SERVICE BULLETIN

PUBLICATION GROUP, AFTER SALES SERVICE DEP.
MITSUBISHI MOTOR SALES EUROPE BV

SERVICE BULLETIN		Nr.: ESB-99E52-900	
		Date: 2000-09-15	<Model> <M/Y>
Subject:	CORRECTION OF CONNECTOR NUMBERS IN SRS-DIAGNOSTIC PROCEDURE.	(EC) SPACE STAR	99-10
Group:	INTERIOR		
INFORMATION/CORRECTION		 O. Kai - E.V.P. & G.M. After Sales Service Dept.	
1. Description:			
Connector numbers of the SRS-system in diagnostic procedures have been corrected.			
2. Applicable Manuals:			
Manual	Pub. No.	Language	Page(s)
	CMXE99E1	(English)	52B-10
	CMXS99E1	(Spanish)	52B-10 – 52B-18
	CMXF99E1	(French)	
	CMXG99E1	(German)	
	CMXD99E1	(Dutch)	
	CMXW99E1	(Swedish)	
	CMXI99E1	(Italian)	
3. Details:

Code No.93 Side impact sensor (L.H.) communication system

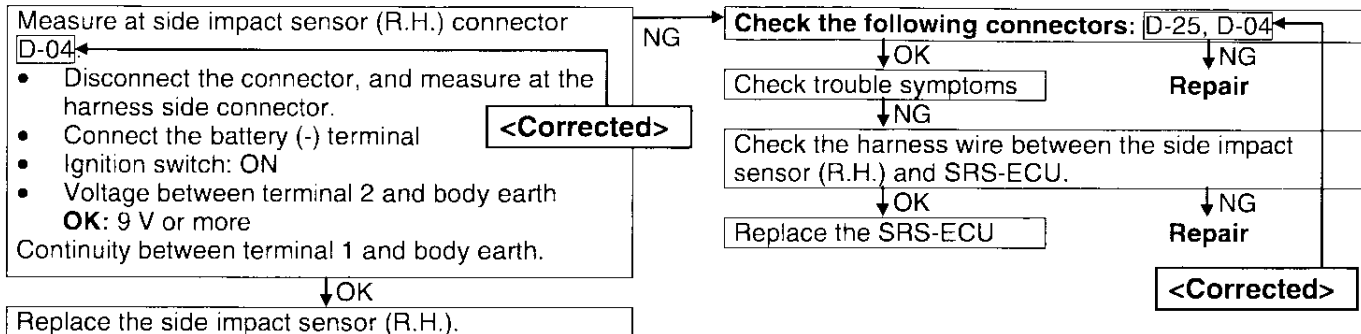
Check the following connectors: D-25, D-18

<Corrected>
